Re: Initial Submission Review – The Overlook at Sorrell Ranch – Site Plan/Preliminary Plat Comment Responses

Application Number: DA-1379-26
Case Number: 2019-4017-00; 2019-3050-00

OVERLOOK AT SORREL RANCH
PRELIMINARY PLAT

S-1

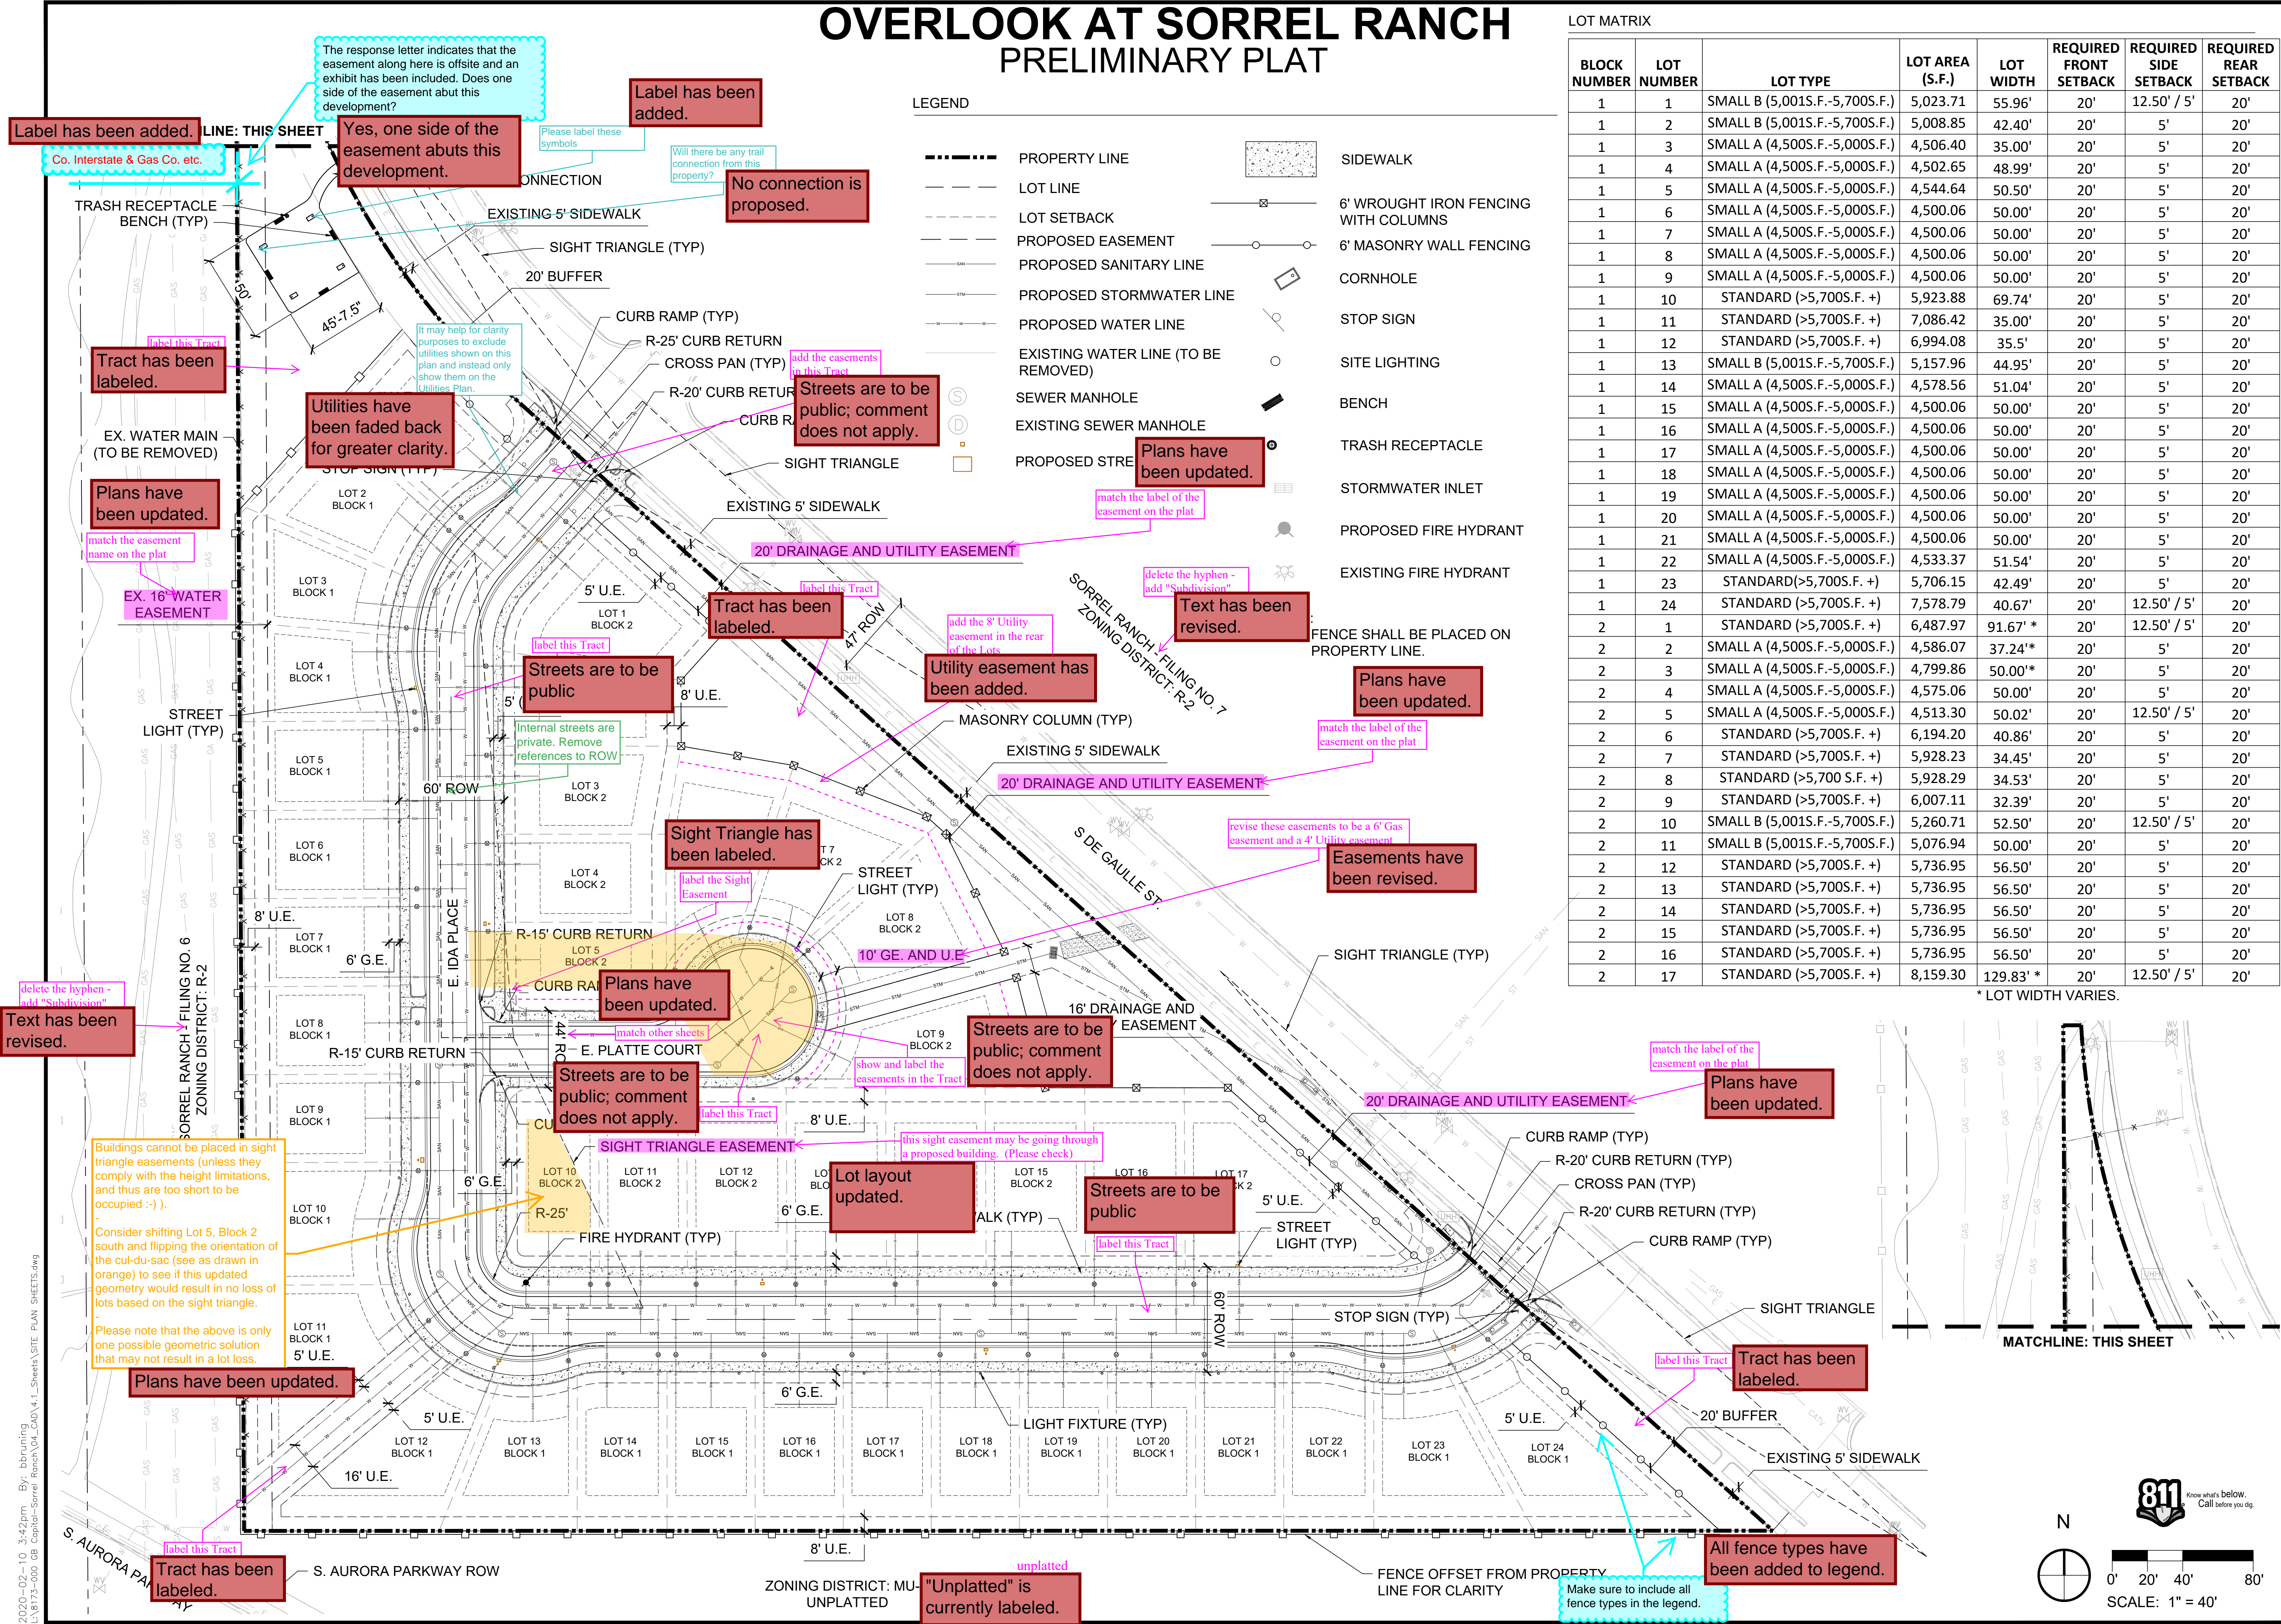
Internal streets are private. Remove references to ROW

Streets are to be public

WROUGHT IRON FENCE WITH COLUMNS
N.T.S.

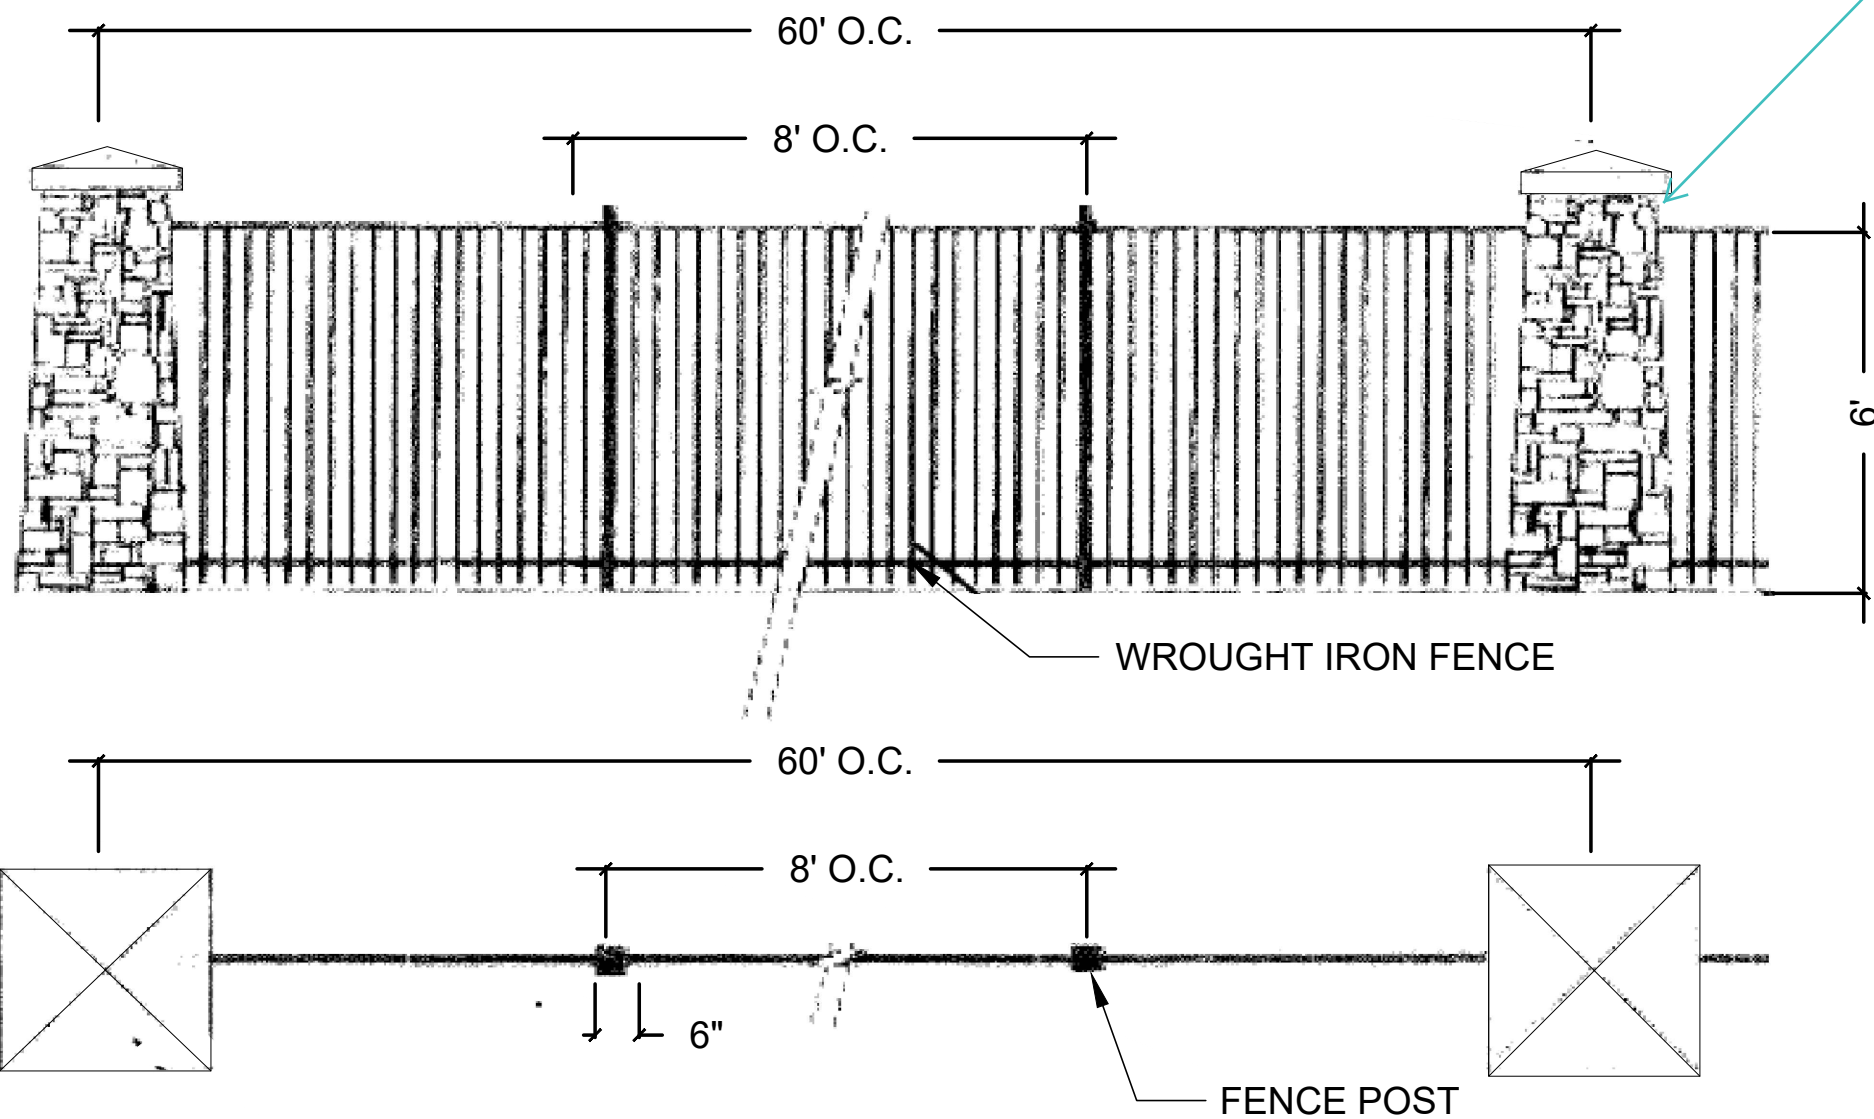
Label column material similar to the masonry fence detail

Column material has been added.

U-1

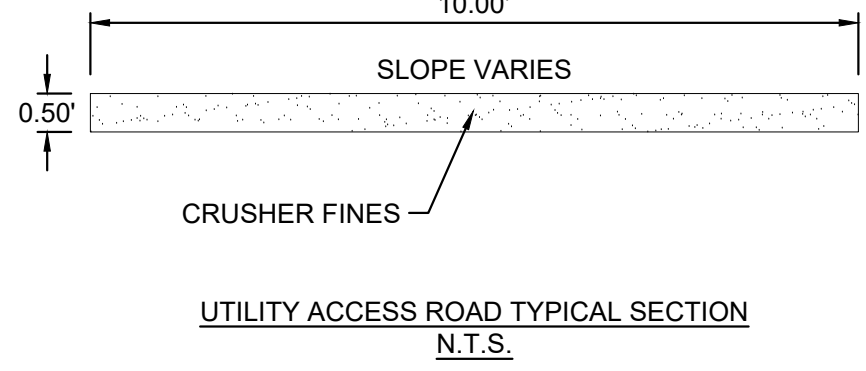
match the label of the easement on the plat

add the 8' Utility easement in the rear of the Lots

revise these easements to be a 6' Gas easement and a 4' Utility easement

this sight easement may be going through a proposed building. (Please check)

add Tract label

NOTED, LABEL WILL BE UPDATED TO MATCH PLAT

8' UTILITY EASEMENT ADDED TO REAR OF LOTS

EASEMENTS HAVE BEEN REVISED TO BE 6' GAS EASEMENT & A 4' UTILITY EASEMENT

CUL-DE-SAC AND LOT LAYOUT UPDATED TO RESOLVE THIS ISSUE

THIS IS TO BE PUBLIC ROW NOT A TRACT

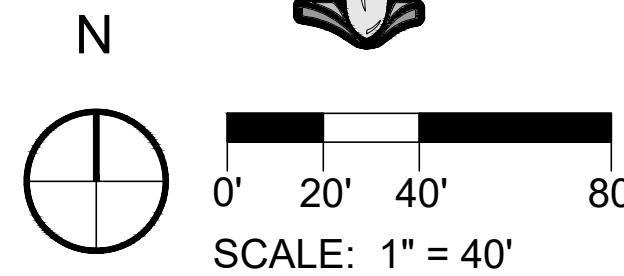
Don't hatch the mulch areas. Just handle that with a note. The hatching makes it more difficult to see the actual plant material for inspection purposes.

Make sure the first tree is 50' from the face of the stop sign. This may need to be removed all together given the likely location of the driveway.

Mulch hatch has been removed. Note specifying mulch type has been added to this sheet. Refer to #3 under "Notes"

MINIMUM FRONT YARD LANDSCAPE TYPICAL

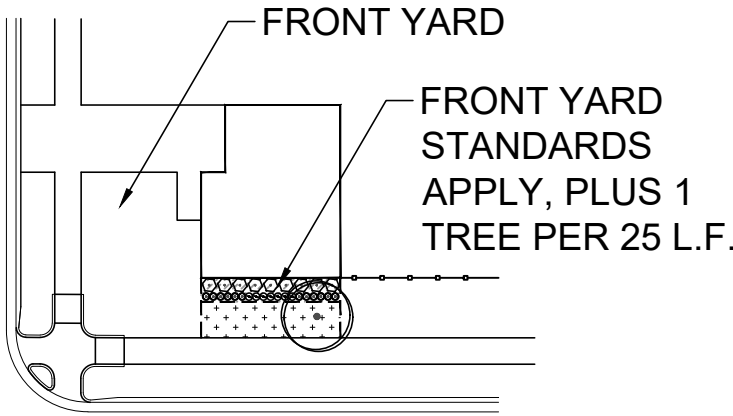
Inspectors will not be calculating the quantities for the front yards. Based upon the square footages of the lots being proposed. Please provide a range of shrubs to be installed in the front yards. For example, a 4,500sf to 5,500sf lot will have "X" total shrubs. A 5,500sf to 6,500sf lot will have "Y" number of shrubs.

A landscape inspection sheet has been created with the required tree and shrub quantities based upon lot size and is included with the response letter.

DRAWING: PHOTOMETRIC PLAN

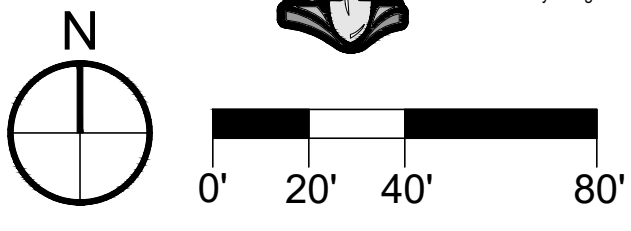
Street lights on DeGaulle Street are public and will be owned and maintained by the City. Please refer to the draft lighting standards for fixtures and other requirements.

Add a note that states street light locations are conceptual. Final street light locations will be determined with the photometric analysis provided with the civil plan submittal

Street lights on DeGaulle are installed and currently exist. No additional lighting on DeGaulle is proposed.

Note has been added.
